ADDENDUM NO. 1

WASHINGTON STATE PARKS AND RECREATION COMMISSION NISQUALLY STATE PARK NEW FULL-SERVICE PARK PHASE 2 NW-C1218

DATE: May 1, 2024

SITE PLAN ADMIN
BUILDING
A-C2.2

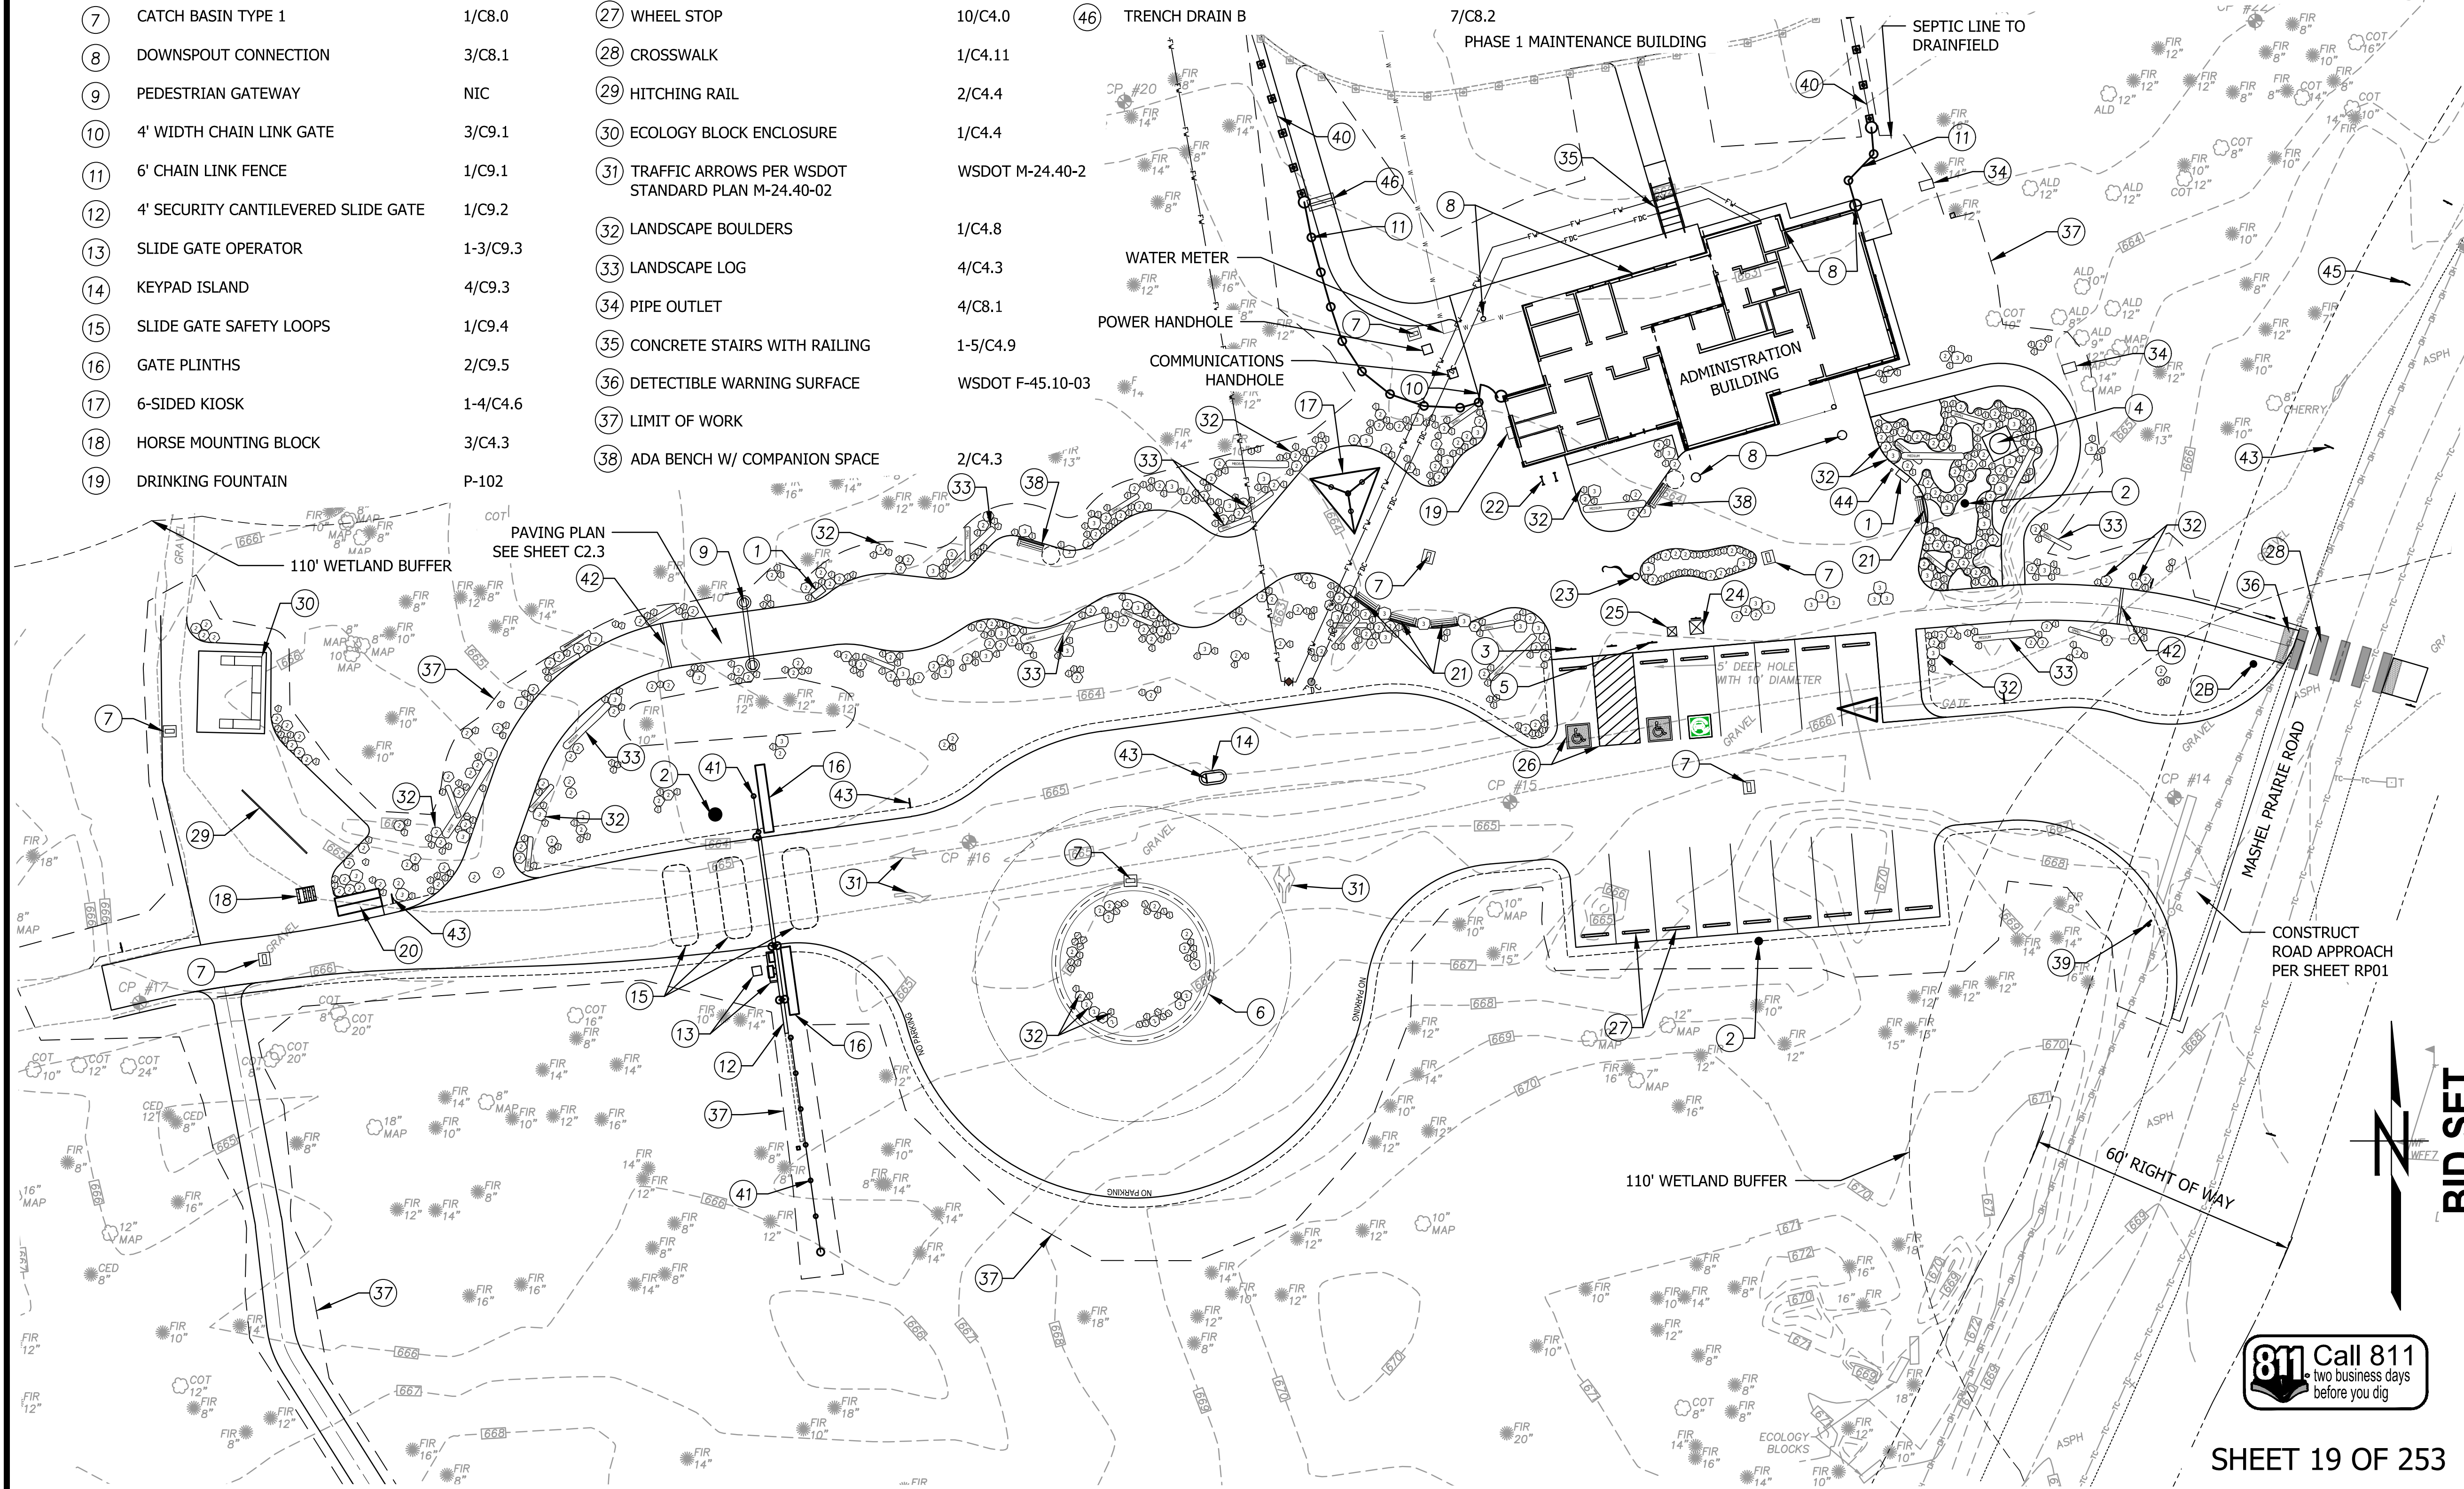
CAD NO.	4/29/2024	DATE
		APP.
		INT.
		REVISONS
ADDENDUM #1 -INTERPRETIVE SIGNAGE EDITED TO NIC TO MATCH SIGNAGE PLANS		
		NO.

DEMO & TESC PLAN -
BUS PARKING
B-D4.0

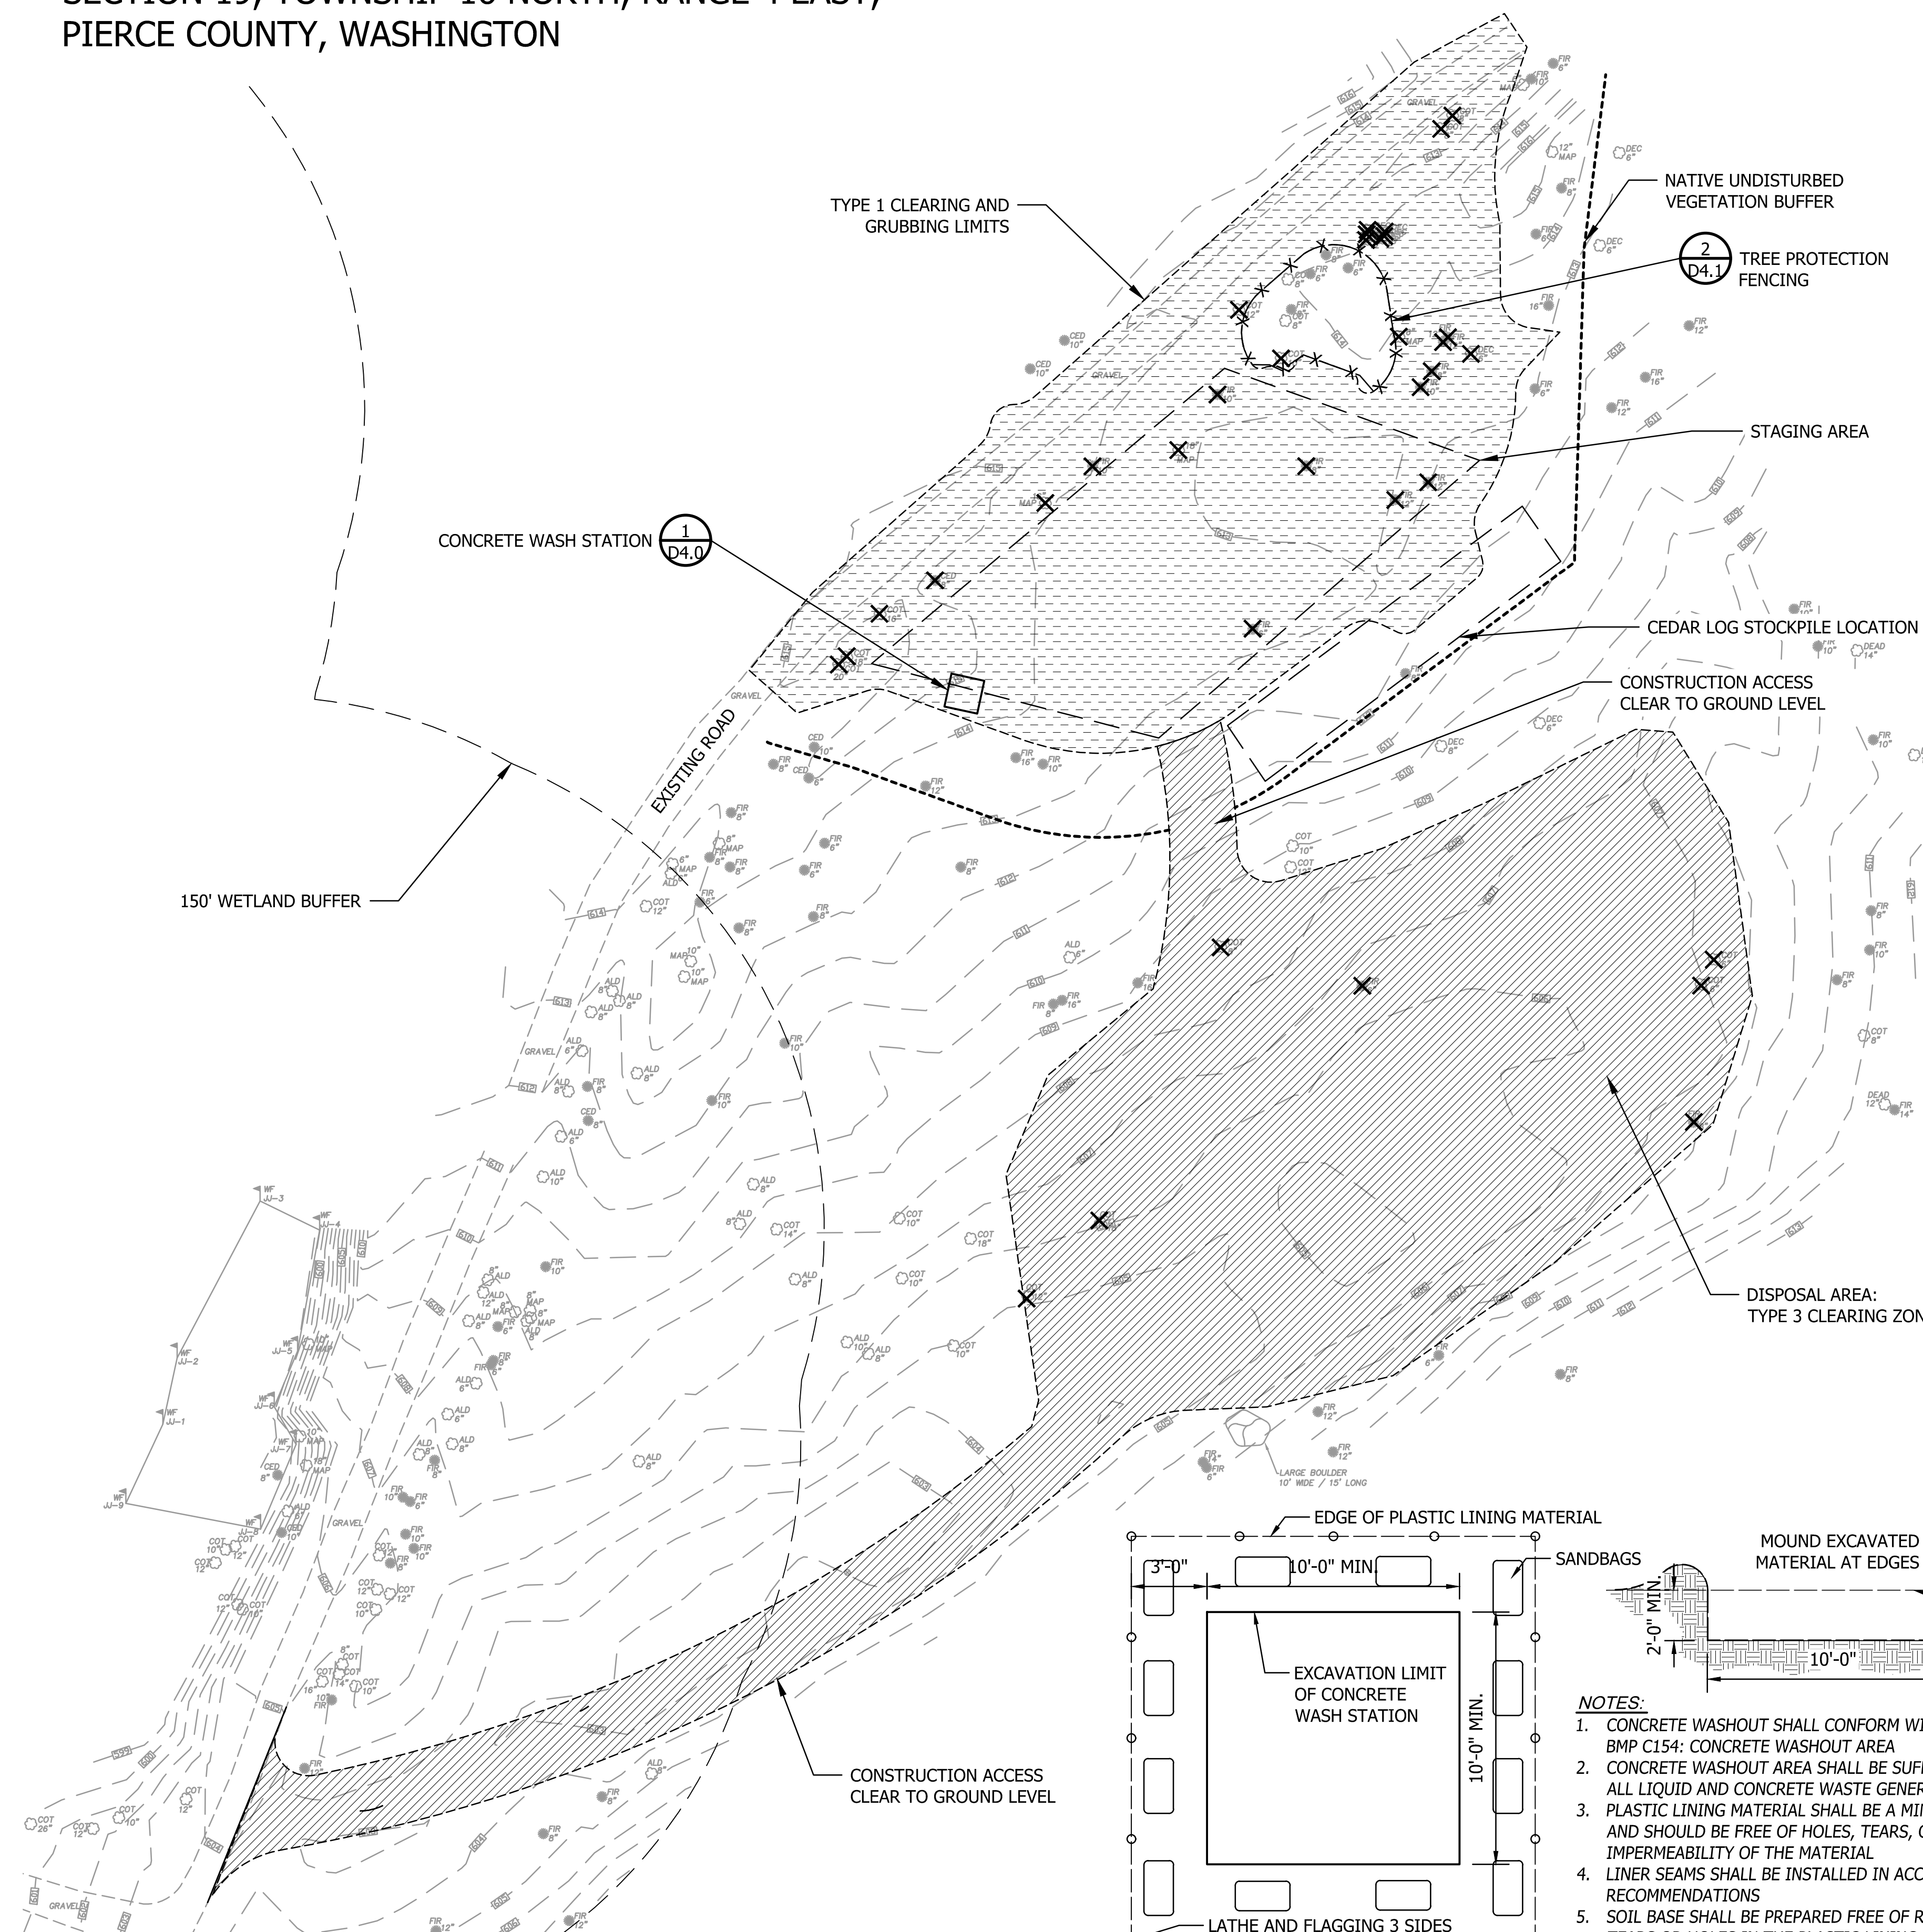
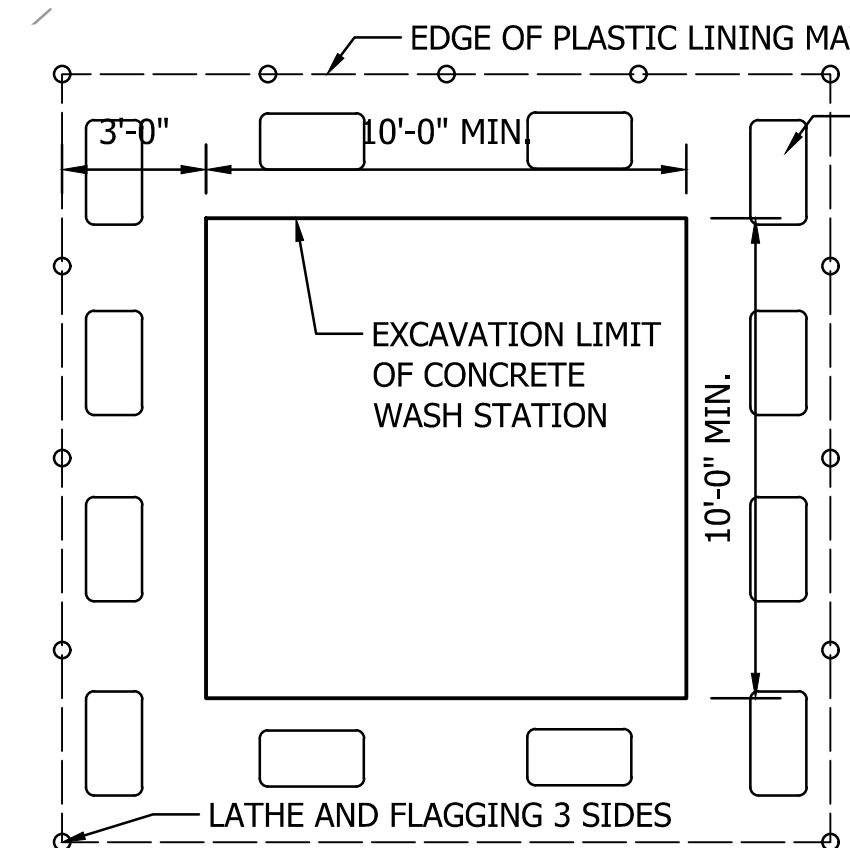
CAD NO.		
	4/29/2024	DATE
		APP.
		INT.
		REVISONS
ADDENDUM #1		NO.
-REVISE GRUBBING TO 12" DEPTH		
-REMOVE CEDAR TREES TO BE SALVAGED FOR TRIBE

-  TYPE 1 CLEARING AND GRUBBING: CLEAR & GRUB TO 12" DEPTH AND DISPOSE IN DISPOSAL AREA (24,900 +/- SF)
-  TYPE 3 CLEARING (36,300 +/- SF)
-  CUT AND CHIP EXISTING TREES, WOOD CHIPS TO BE STOCKPILED ON SITE FOR LATER USE. (35 +/- TREES)
-  25' NATIVE UNDISTURBED VEGETATION BUFFER DOWN SLOPE EDGE, PER BMP C234
-  TREE PROTECTION FENCE
-  STAGING AREA
